# **SHEPLEY'S HILL LANDFILL SUPPLEMENTAL GROUNDWATER AND LANDFILL CAP ASSESSMENT FOR LONG-TERM MONITORING AND MAINTENANCE – ADDENDUM REPORT**

**FORMER FORT DEVENS ARMY INSTALLATION, DEVENS, MA**

Subject: **Shepley's Hill Landfill – Supplemental Groundwater and Landfill Cap  
Assessment for Long-term Monitoring and Maintenance Addendum Report  
(Final Version)**  
Contract Number GS-10F-0230J, Delivery Order W912WJ-05-F-0037

Subject: **Shepley's Hill Landfill – Supplemental Groundwater and Landfill Cap  
Assessment for Long-term Monitoring and Maintenance Addendum Report  
(Army Draft)**  
Contract Number GS-10F-0230J, Delivery Order W912WJ-05-F-0037

**FIGURE 9**  
**GEOLOGICAL CROSS SECTION D-D'**  
**DISSOLVED ARSENIC CONCENTRATIONS**

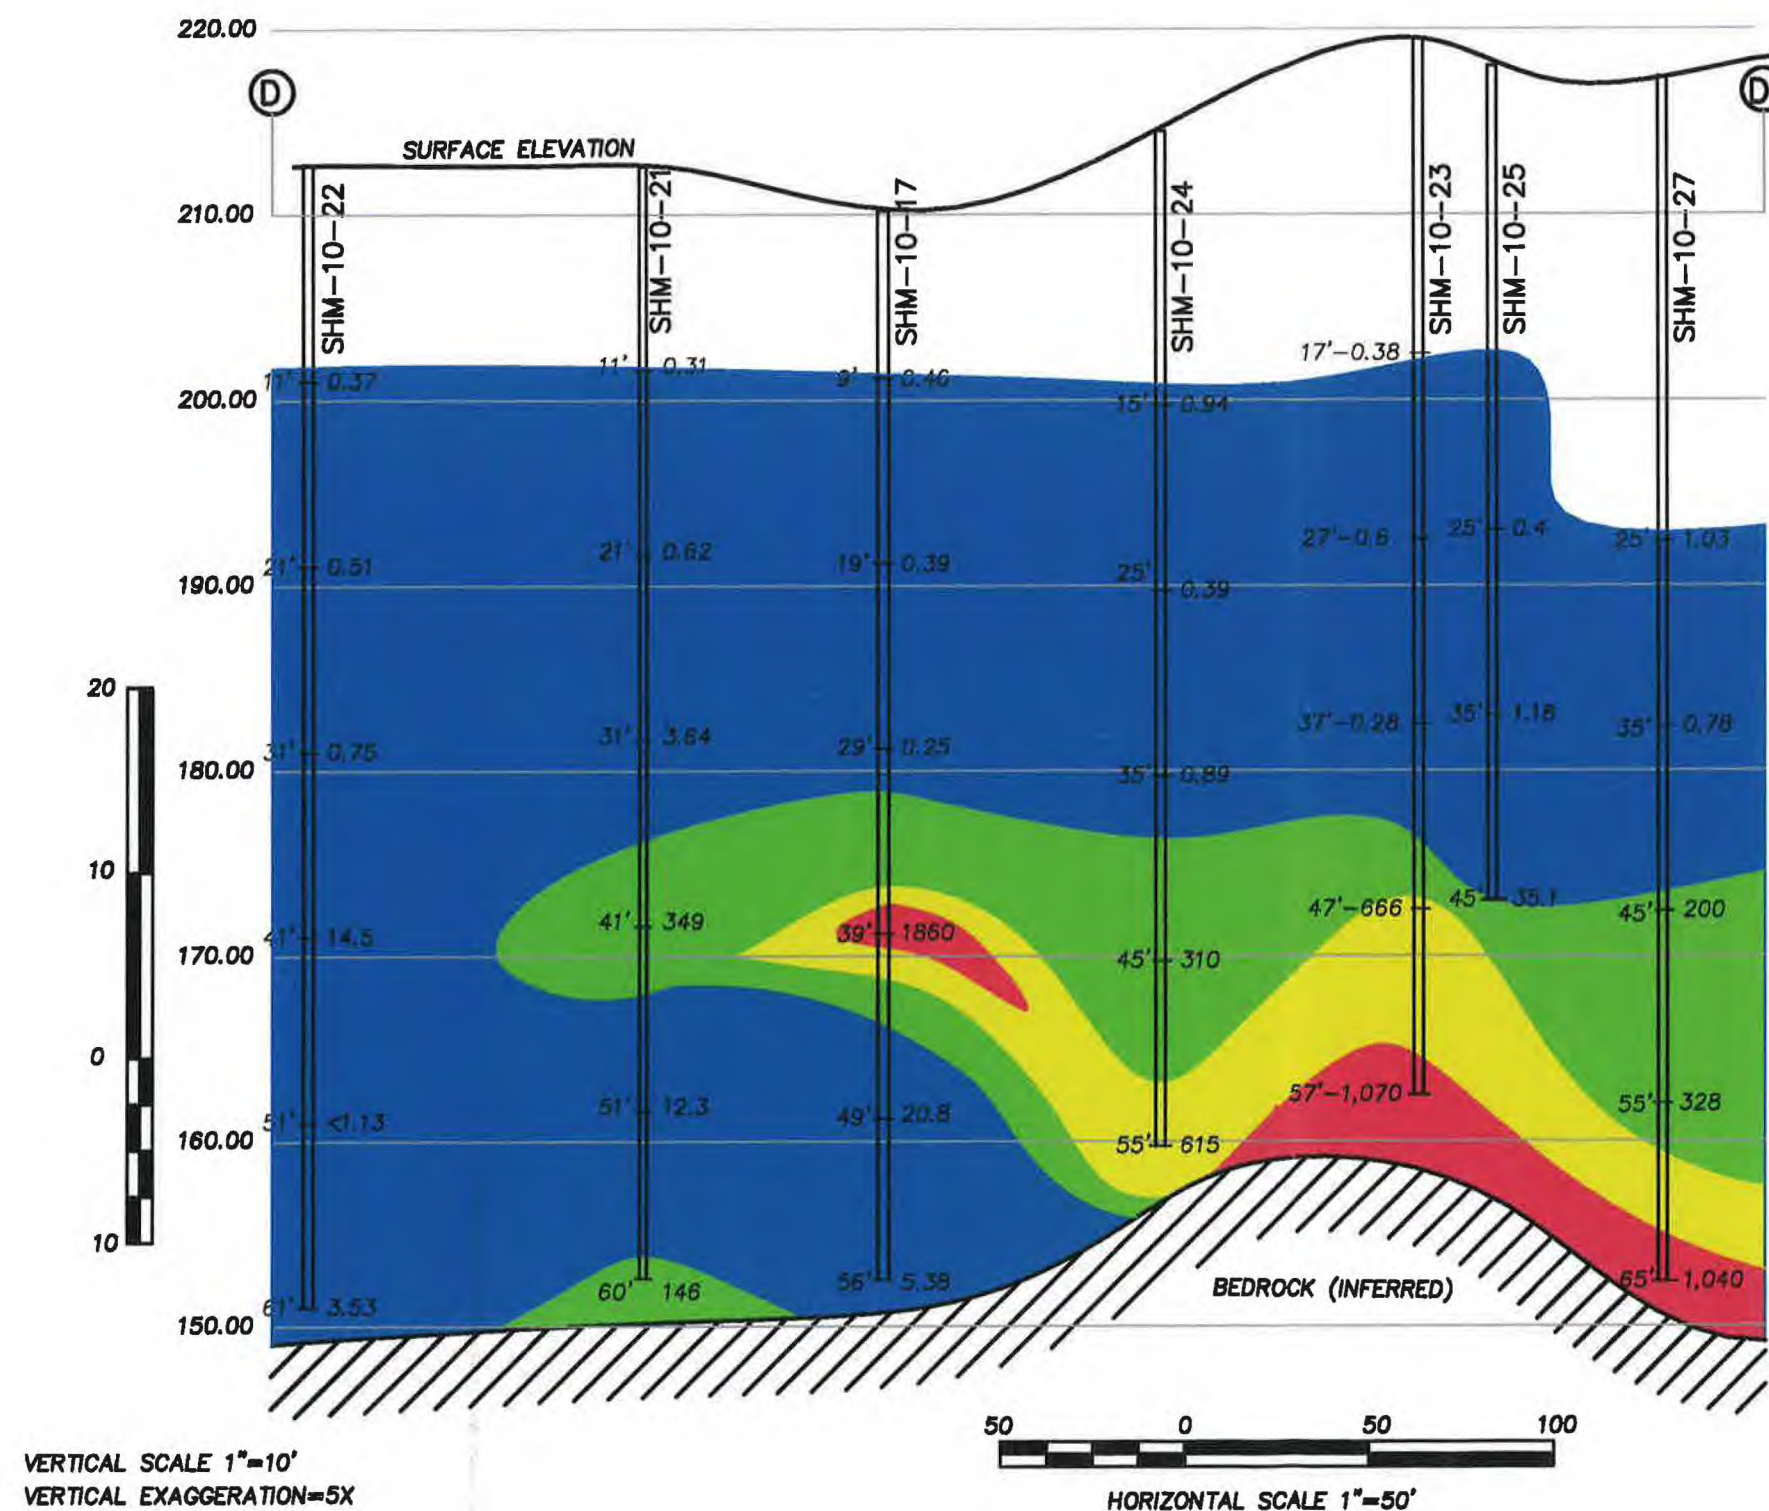
- The results from the 2010 field effort indicate that vertical flow and discharge to Nonacoicus Brook and adjacent wetlands, rather than precipitation along a “redox boundary”, may explain the observed arsenic distribution. In particular, cross sections D-D' and F-F' indicate that the plume may ascend from depth to discharge points in Nonacoicus Brook and the adjacent wetlands (note the upward trajectory of the plume core between wells SHM-10-27 and SHM-10-21 in Figure 9 and between SHM-10-23 and SHM-10-19 in Figure 11).

Bedrock contouring also plays a part in this upward trend reflected in Figures 9 and 10. Next, surface water and sediment sampling conducted by Harding in 2002 and AMEC in 2007 show no conclusive evidence that SHL is a source of a surface water / sediment impact. Each of these two sampling programs reported the highest arsenic concentrations within samples obtained from the upstream Sawmill Brook sampling points. Future surface water / sediment sampling will be performed periodically to confirm these results pending implementation of an updated remedy for SHL.
